Notice of Allowability

10/664,138

EXAMINER'S AMENDMENT

Fig - 3A

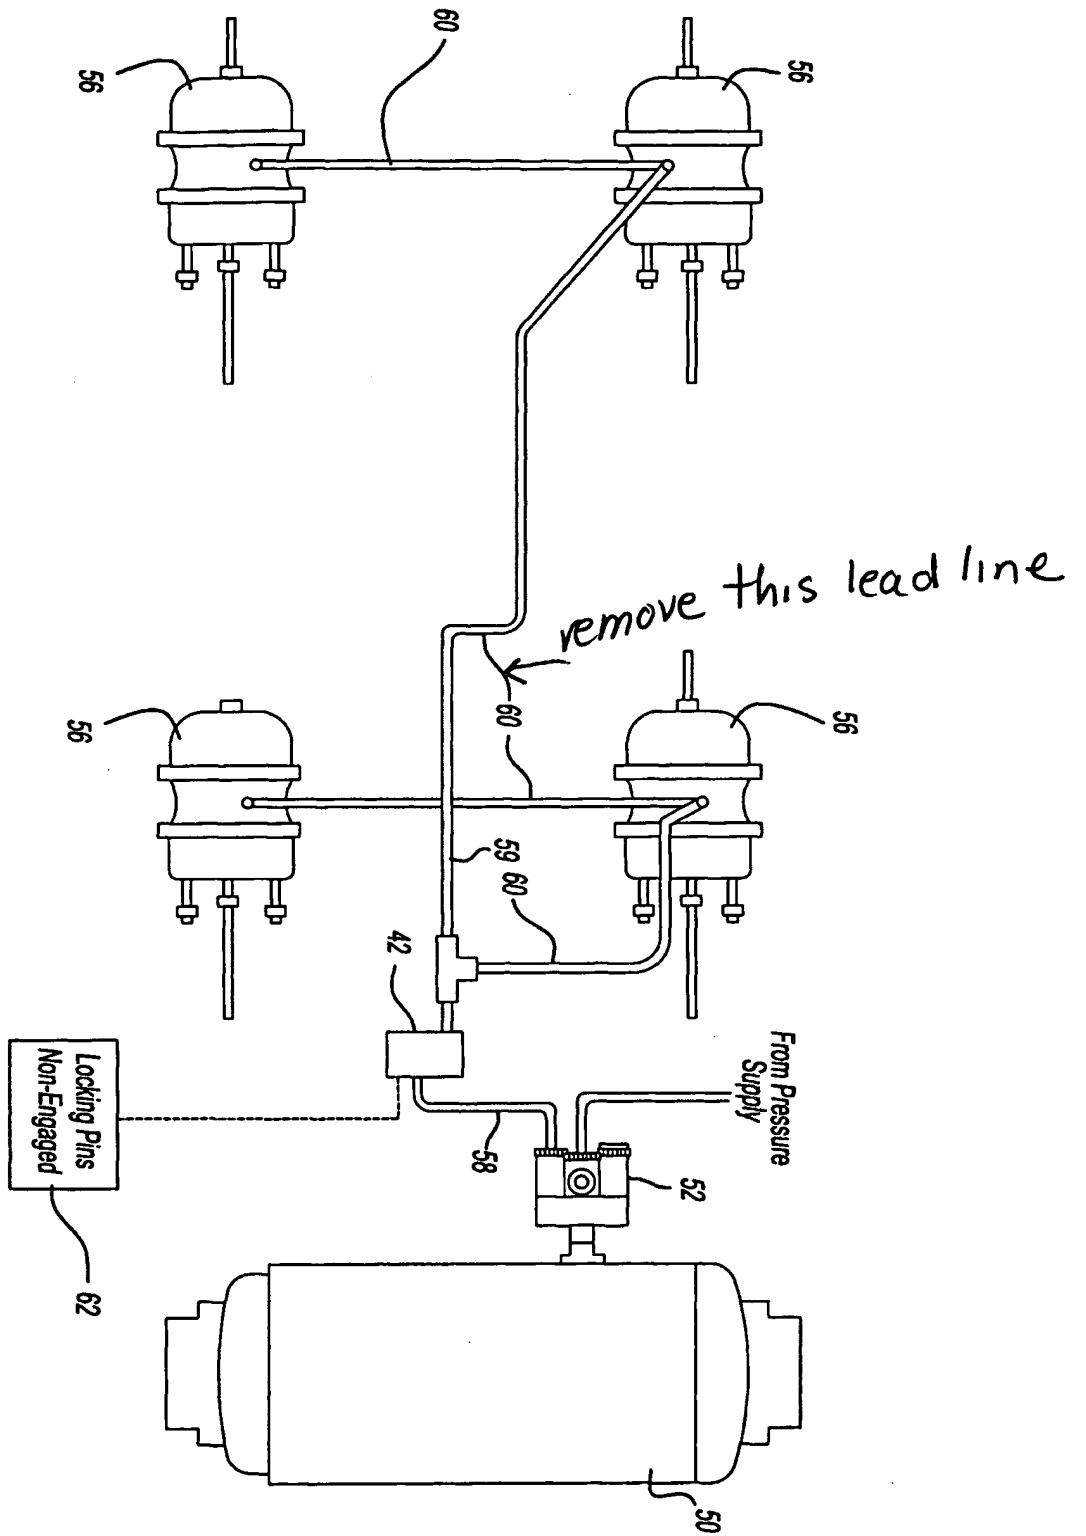
2. The following changes to the drawings have been approved by the examiner and agreed upon by applicant: As shown in the attached Figure, the second lead line associated with the reference 60 in the center of the page has been deleted. In order to avoid abandonment of the application, applicant must make these above agreed upon drawing changes.
